Technical Note

201-27 (202, 203, 204)
205-17, 206-14
301-34, 303-15, 304-5
401-21, Falcon Nr.2

Subject: Elevator actuating bracket

201-33-4

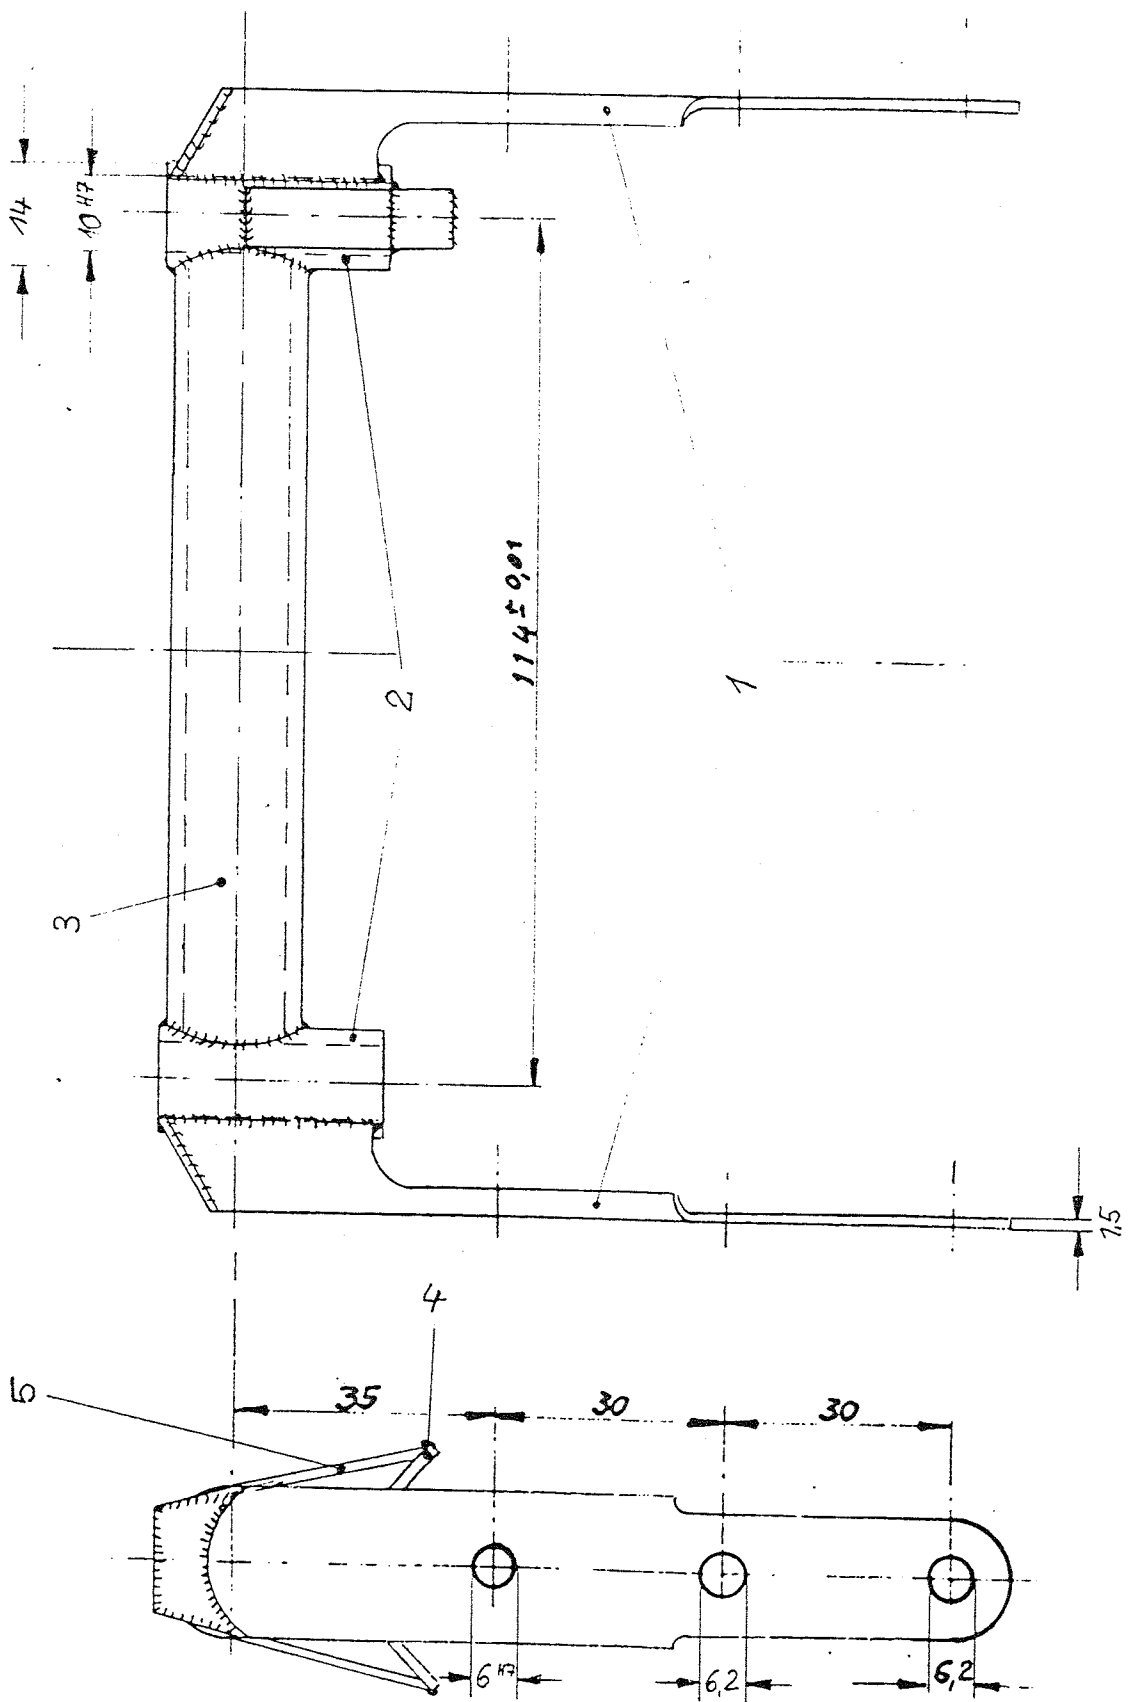
Reason: Use of a bracket as per drawing no. 201-33-4 instead of former bracket types permissible.

Actions: In case of elevator actuating exchange use following procedure:
Unscrew the 6 screws on the elevator actuating bracket. Pay attention to the type and number
of washers at each bolt. Mark position precisely!
Install new actuating bracket including the washers on the same position.
Tighten screws carefully and check free motion of the elevator.

Material: Elevator actuating bracket according to drawing no. 201-33-4 is available from
